**From:** Mookhoek, William [wemookhoek@STPEGS.COM]  
**Sent:** Thursday, July 10, 2008 10:16 PM  
**To:** Gibson, Gregory T; George Wunder; Raj Anand; Rocky Foster; Tekia Govan; Tom Tai; Adrian Muniz; Belkys Sosa; STPCOL  
**Subject:** RE: RESENT: RAI responses Report # ABR-AE-08000046  
**Attachments:** STP34\_ABR-AE-08000046.pdf

June 26, 2008  
ABR-AE-08000046

South Texas Project  
Units 3 and 4  
Docket Nos. 52-012 and 52-013  
Response to Requests for Additional Information

**FIGURE 1 Palacios Annual Wind Rose**

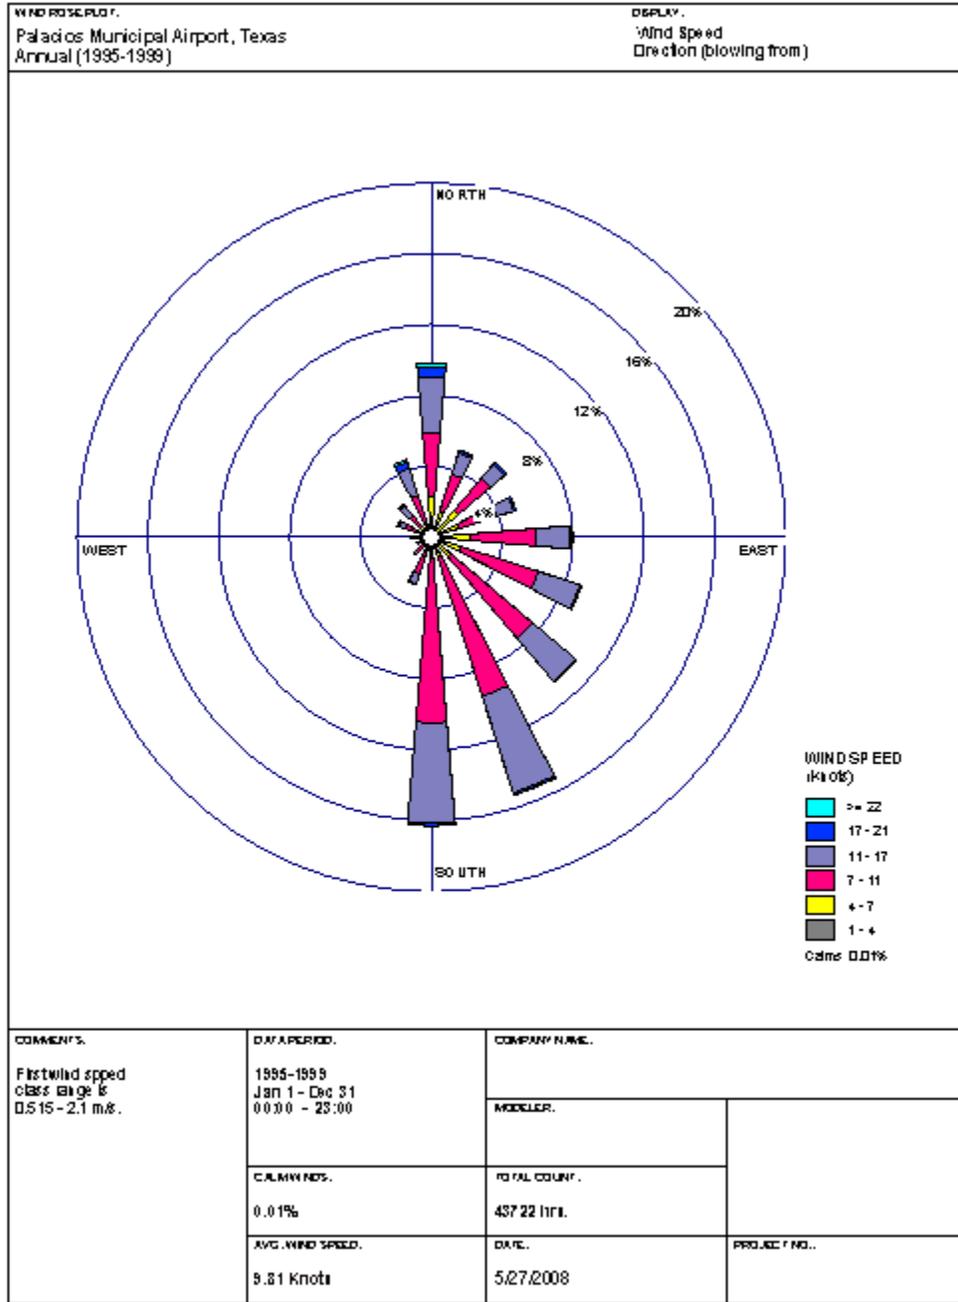
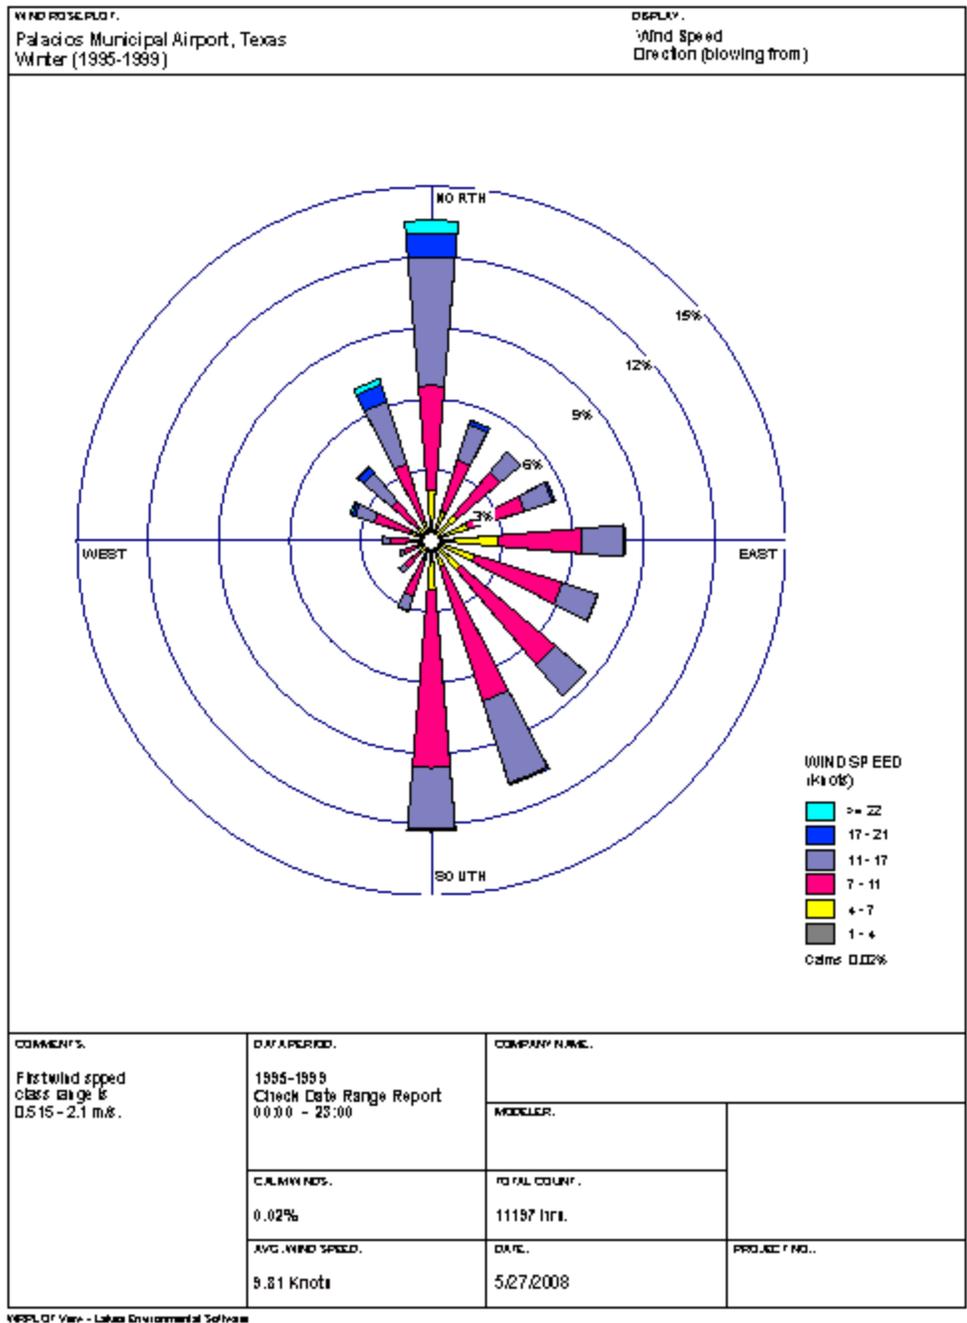
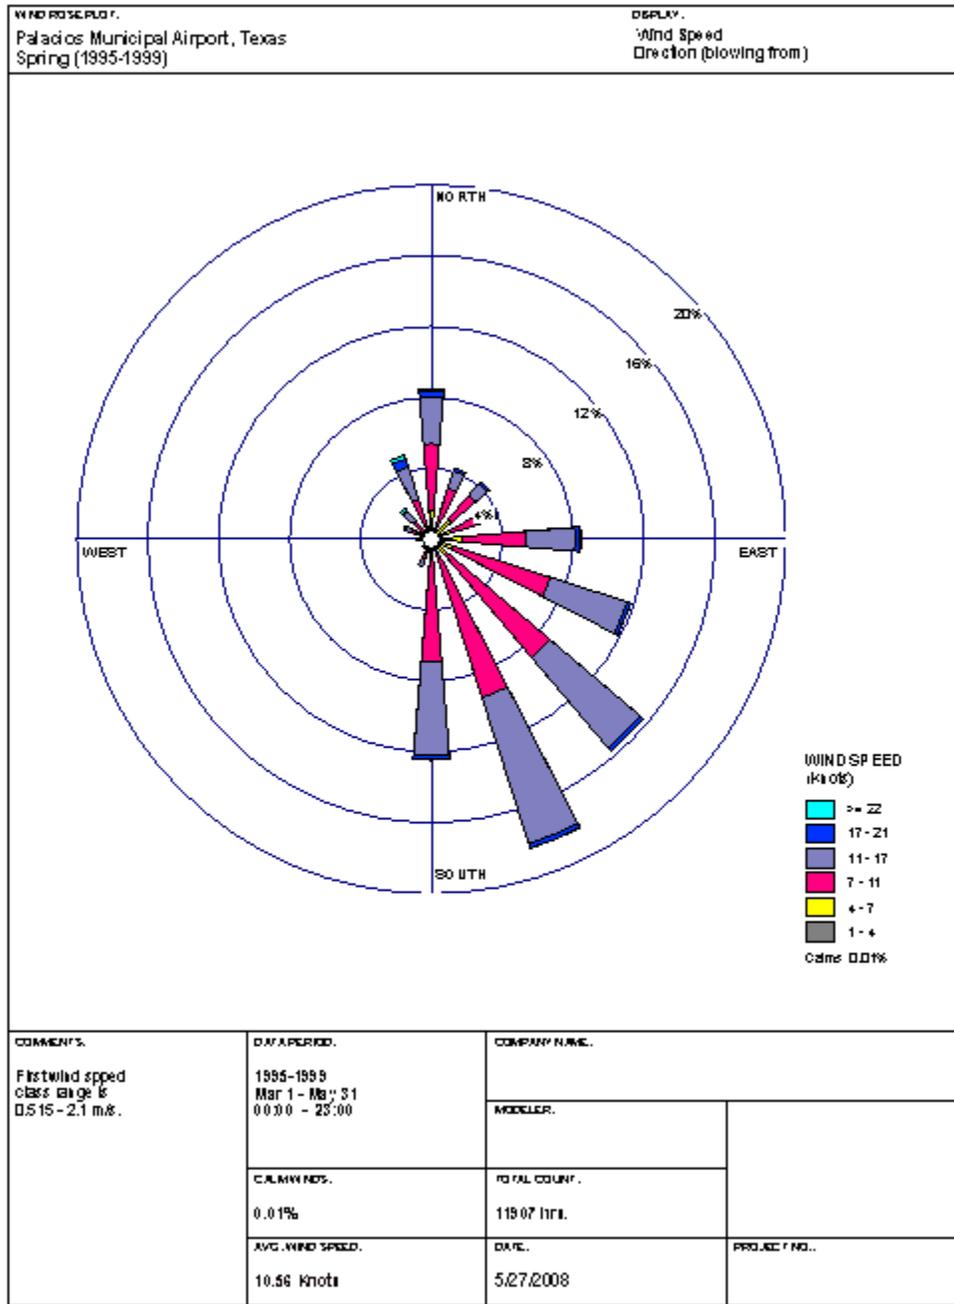
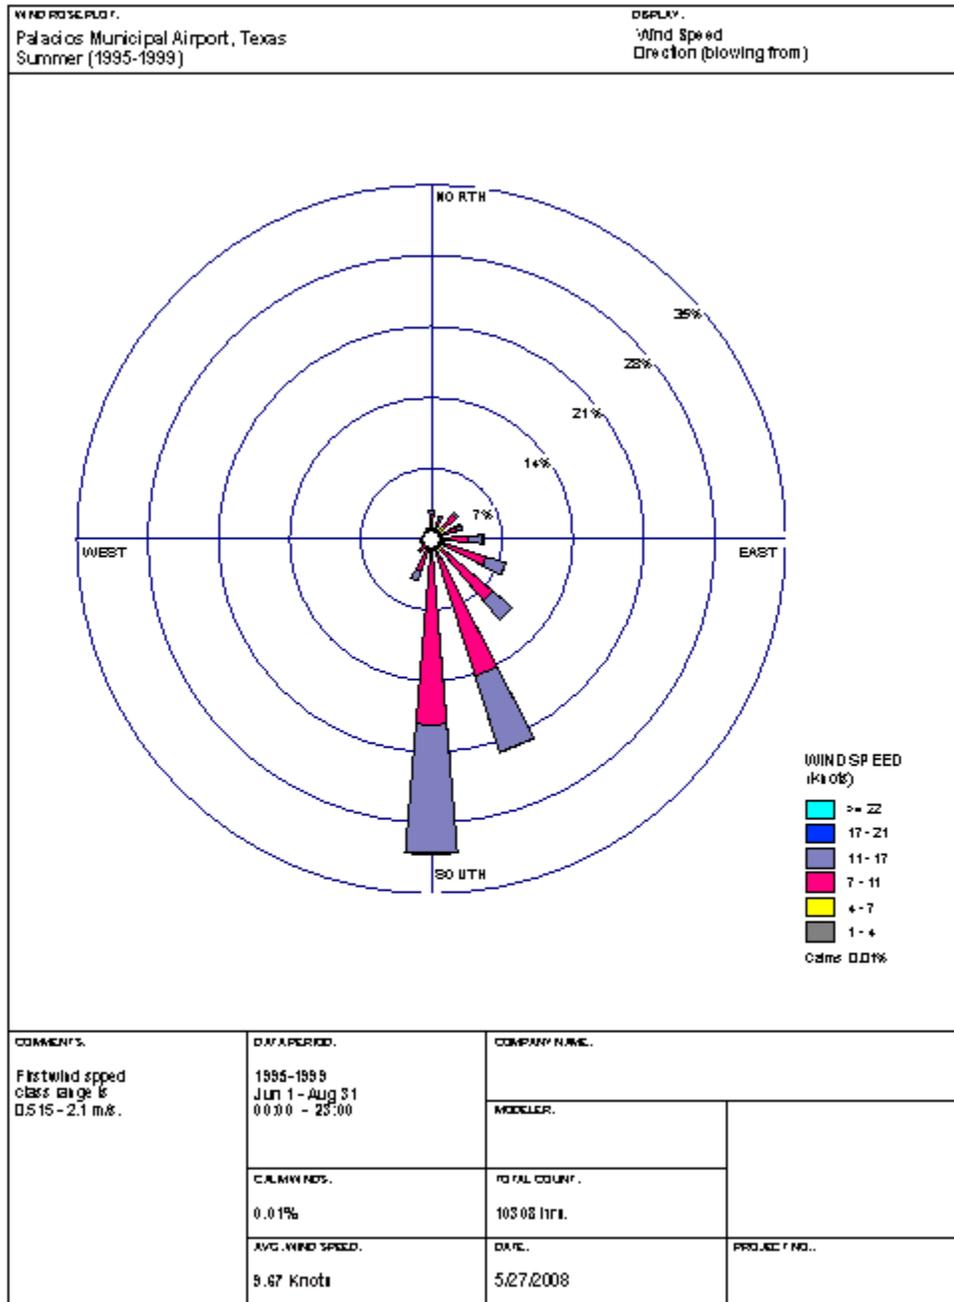
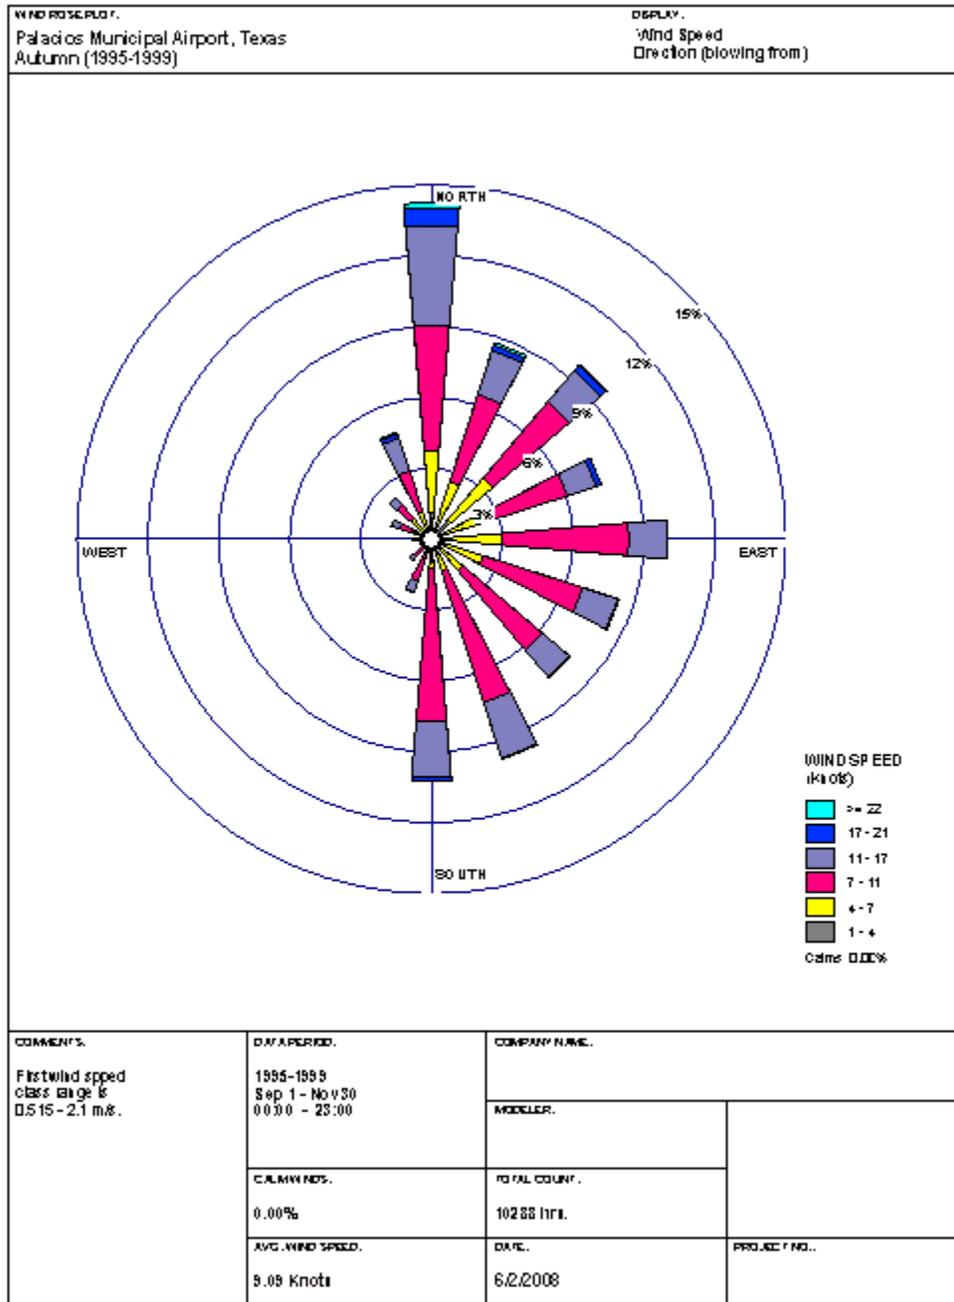
**Question 02.03.02-4****QUESTION:**

(a) A 5-year period (i.e., 1995 through 1999) of wind measurements from the cooperative observing station at the Palacios Municipal Airport (Reference 1) has been evaluated. Longstanding U.S. EPA guidance has determined that for dispersion-related analyses, variations over a 5-year period of record are representative of longer duration data sets. Wind roses based on this data set for Palacios (Figures 1 through 5) show reasonably similar characteristics in predominant directions on an annual basis when compared to the onsite annual wind rose (see Figure 2.3S-2) (i.e., from the southeast through south sectors) and as indicated in the 2005 Local Climatological Data (LCD) summary for the Victoria National Weather Service (NWS) station (see Table 2.3S-2) (i.e., a prevailing direction of 160° or from the south-southeast sector).

Specific differences in directional frequencies and mean wind speeds may be due to station siting and instrumentation, and to different periods of record among the three stations. Nevertheless, the wind direction and wind speed data show reasonable intermediate-field (Palacios) and far-field (Victoria) similarity to the wind conditions measured at the STP site.

Based on the 5-year period of record from 1995 through 1999, wind direction measurements from the cooperative observing station at the Palacios Municipal Airport (Reference 2.3S-27) show reasonably similar characteristics in predominant directions on an annual basis. At both locations, reasonably similar variations in the predominant wind direction sectors over the course of the year are also evident.
